**To:** Wang, Gary[wang.gary@epa.gov]  
**Cc:** Gallant, William[Gallant.William@epa.gov]; Suchomel, Bruce[Suchomel.Bruce@epa.gov]; Breffle, Don[Breffle.Don@epa.gov]; Pardue-Welch, Kimberly[Pardue-Welch.Kimberly@epa.gov]; Rodrigo Jurado[rjurado@pgei.com]  
**From:** Kevin Dickey  
**Sent:** Tue 9/22/2015 1:33:40 PM  
**Subject:** FW: Step rate test for Petroglyph's Ute Tribal 29-12 injection Well (EPA ID UT20736-04523)  
[Antelope Creek Injection Water Analyses.pdf](#)

RE: Your September 11<sup>th</sup> email to Rodrigo Jurado denying Petroglyph's step rate request on the UT 29-12

**Subject:** Step rate test for Petroglyph's Ute Tribal 29-12 injection Well (EPA ID UT20736-04523)

# UT 29-12 Injector June 2015 Step Rate Test after adding shallow "B" perfs

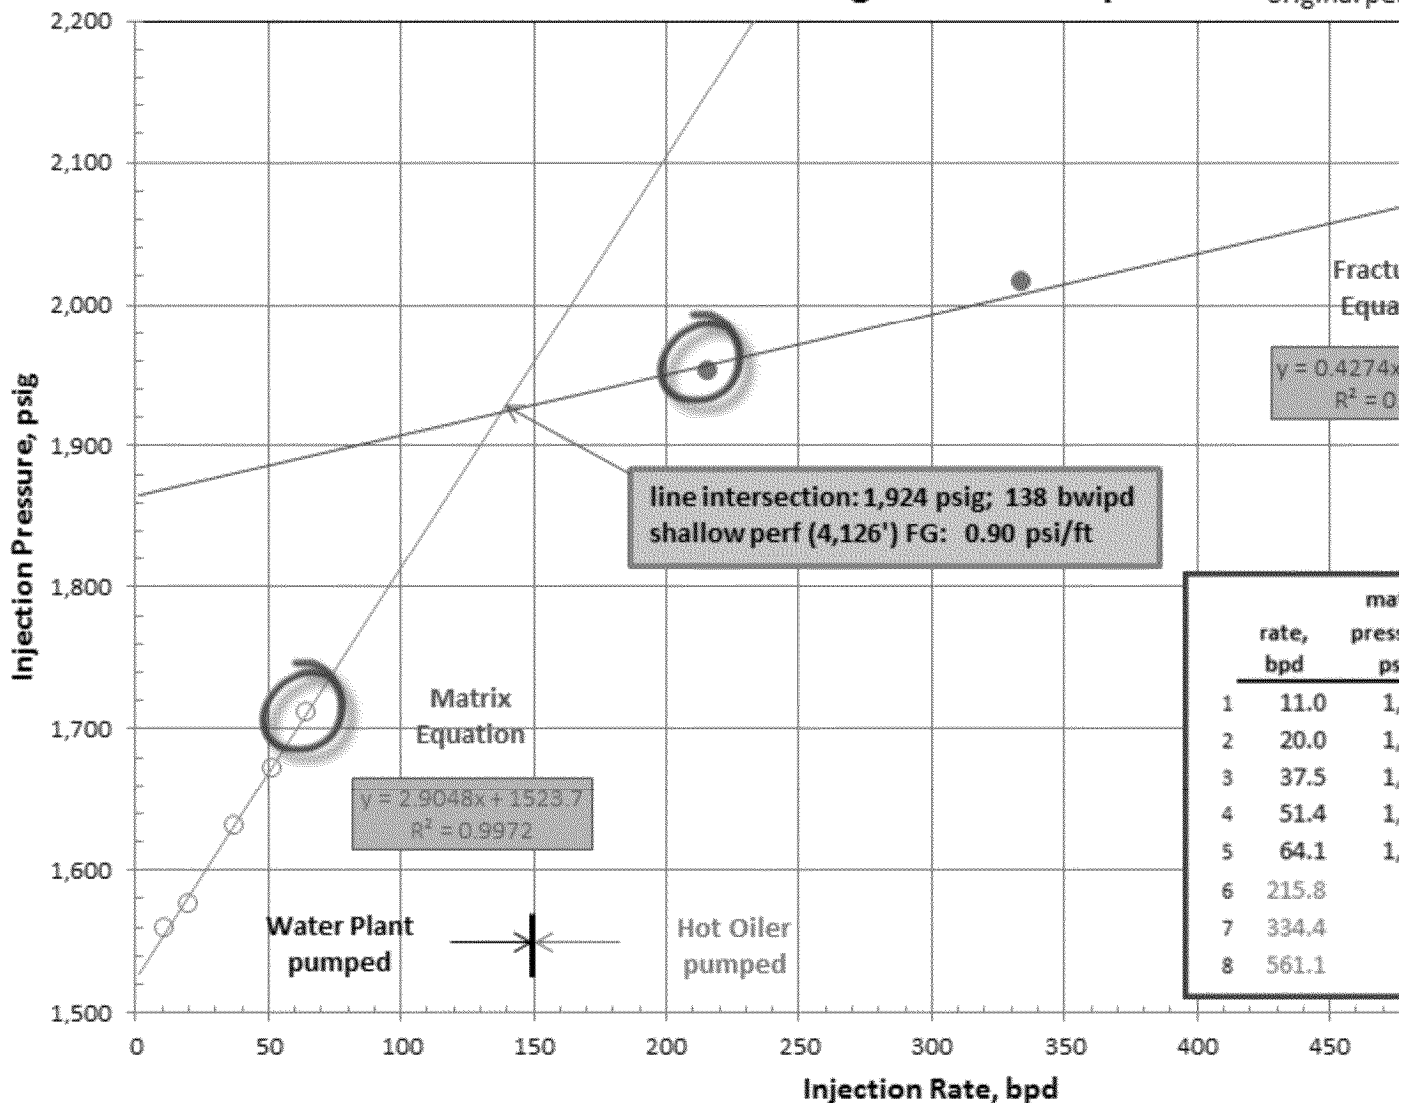
I think we can agree on two points with respect to our step rate test on the UT 29-12 (plot below).

1. On our initial test using our water plant, the last point at 1711.5 psig was on the matrix trend line.
2. The first point on our test pumping water with the hot oiler at 1952.6 psig was not on the matrix trend line.

If this is the case, then we should, at a minimum, be allowed to inject into this well at pressures below 1711.5 psig as we clearly are not fracturing at this injection pressure.

But even so, we still see two distinct slopes:

- ☐☐☐☐☐☐☐ Matrix slope: a 1 bwpd increase in injection raises the pressure 2.9 psi.

- Fracturing slope: a 1 bwpd increase in injection raises the pressure 0.43 psi (nearly 1/7<sup>th</sup> as much)

Based on the review of the data, EPA is not approving the step rate test results based on the following reason:

- A breakdown point was not observed in either event. Because of the two separate events, the result from Petroglyph appear as two disparate slopes used to extrapolate the fracture pressure. Additionally, experimental conditions (e.g., fluid characteristics) may have changed between the two testing events.

We would request an allowable injection rate of 1711 psig for the UT 29-12 injector, which is clearly on the matrix line. Since our plant can't pump steadily above this pressure at this location, this would be adequate for our present purposes. If we need to get a higher injection pressure, in the future, we will rerun the step rate test.

We would like to see the step rate test be retested with the following conditions:

- The step rate test is to be conducted where the plot of the pressure versus rate is experimentally collected in one continuous event, beginning from below the fracture parting pressure, through the breakdown point, and into the above fracture parting pressure.
- After additional discussion with others in the office, we would also like to see both surface and bottom-hole pressures to be observed during the step rate test.
